SHUOYING DIGITAL SCIENCE&TECHNOLOGY(CHINA)Co., Ltd

Declaration

Product Name: Digital Video Camera

Model No.: DV108

Location of modification 1

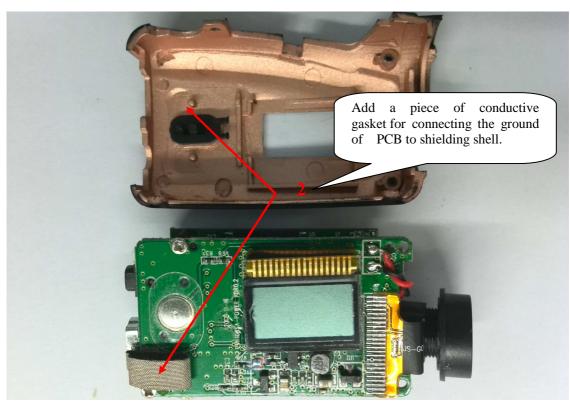
- 1. The EUT shell paint with Conductive paint.
- 2. Add a piece of conductive gasket for connecting the ground of PCB to shielding shell.
- **3.** R9 need change to bead (model: BEAD0402H301T).
- 4. R10 R11 R25 R26 need change to bead (model: BEAD0402H301T).
- **5.** R50 R51 need change to bead (model: BEAD0402H451T).
- **6**. Add a piece of conductive gasket for connecting the two PCB ' ground.
- 7. The USB cable should add a core and shielding.
